Subject: Fee Title Holder Notification of Regulatory Closure of
Former Chevron Service Station #20-6516
2428 Central Avenue, Alameda, California 94501

RE: Well Decommission at 2428 Central Avenue, Alameda, CA

**SUBJECT: INTENT TO MAKE A DETERMINATION THAT NO FURTHER ACTION IS REQUIRED
OR ISSUE A CLOSURE LETTER FOR 2428 CENTRAL AVENUE, ALAMEDA, CA**

Subject: Response to ACEHS Comments Regarding the Risk-Based Corrective Action (RBCA) Evaluation dated April 20, 1997, for the Former Chevron Service Station No. 9-0100, located at 2428 Central Avenue, Alameda, California.

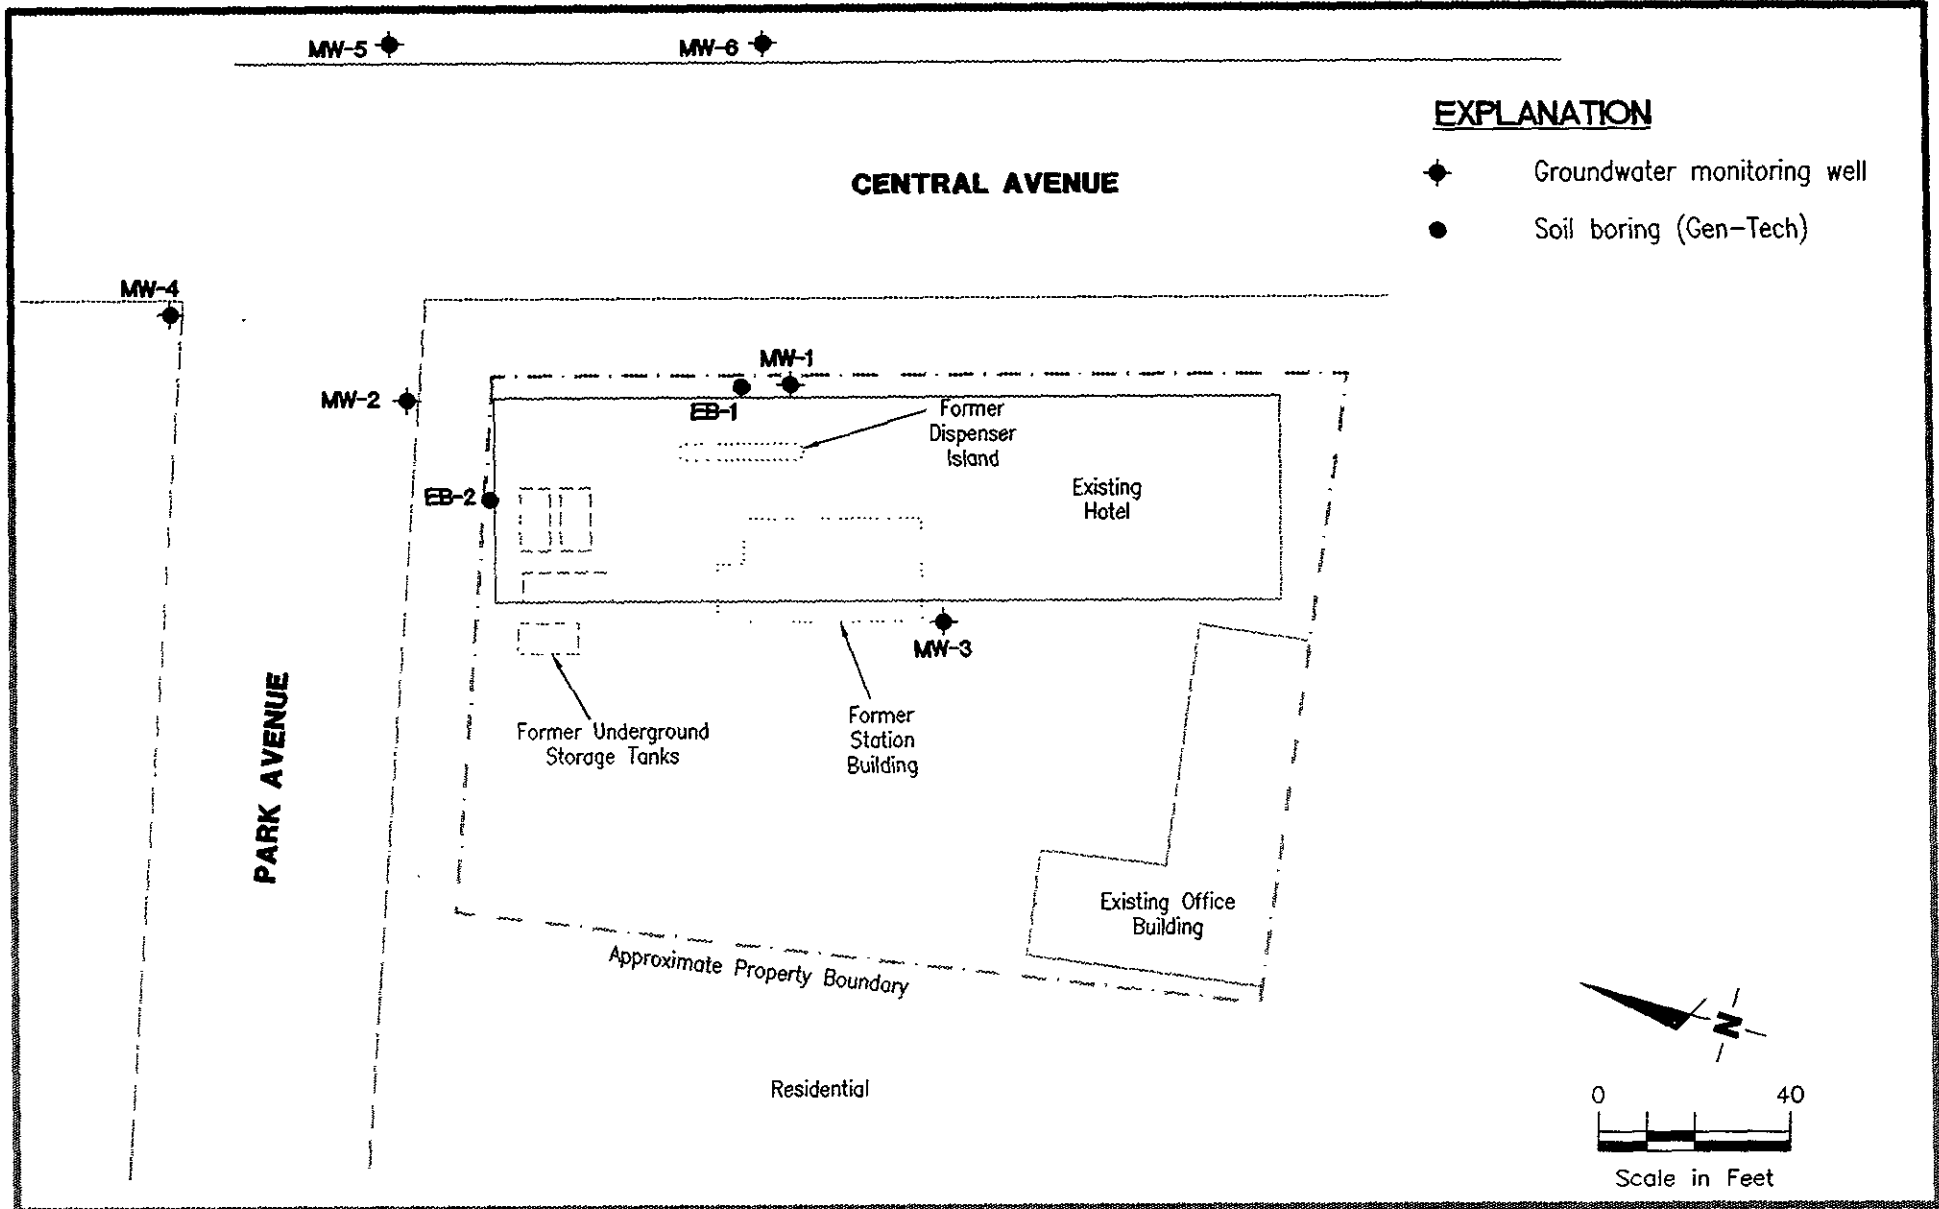
Previous report, they did the calculations for 10⁻⁶ & now for 10⁻⁵ - PASSED
